Western States Petroleum Association
Credible Solutions • Responsive Service • Since 1907

July 27, 2012

Re: **WSPA Comments on July 12 Workshop on the Oil Production GHG Emissions Estimator**

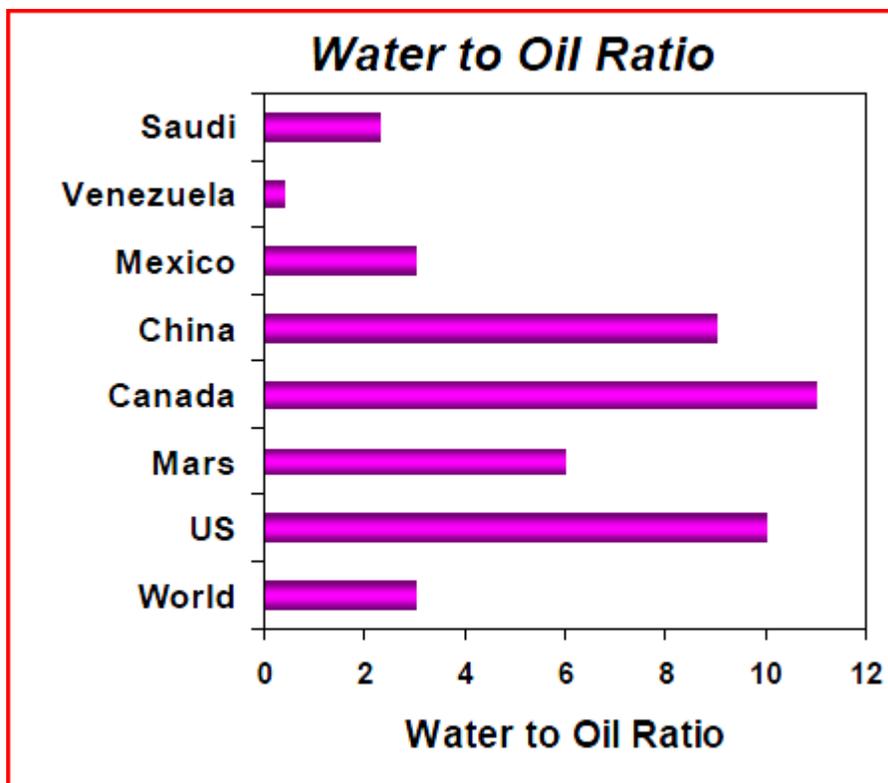
2. The vast majority of crudes assessed by ARB staff use many model defaults; however, the available defaults cannot be applied blindly. As an example, Arab Light, which makes up 8% of the 2010 baseline crude volume, is assigned a water-oil ratio of 17.8 which was derived from the "smart default" curve based on field age. This "smart default" was used despite data available to staff that indicates that the water-oil ratio is actually much lower. The chart reproduced below was taken from a presentation by Jacobs Engineering to the Crude Oil Screening Workgroup obtained from ARB's own web site:

The Jacobs data indicates that the water-oil ratio is about 2 for Saudi Arabian crudes. Staff's use of the "smart default" value rather than the Jacobs data, combined with the very high well flow rates (5700 barrels per day per well versus a model default of 188 barrels per day per well) for Saudi Arabian production, results in the model estimating an unreasonable CI value (> 200 gCO₂e/MJ) when all of the other field-specific inputs and defaults are utilized. Rather than questioning the "smart default", staff appears to have arbitrarily chosen to increase the assumed well diameter for Arab Light and Arab Extra light to 7.5 inches, which is 3 inches larger than the upper range from the literature reported in the OPGEE documentation. The resulting CI value for Arab Light is 12.5 g/MJ. However, if staff had utilized the Jacobs-based water-oil ratio of 2, then the extraordinary well diameter assumption would not have been necessary and the OPGEE prediction for the CI of Arab Light would have been 7.1 g/MJ - which is still high compared to other estimates, but more reasonable than 12.5 g/MJ.
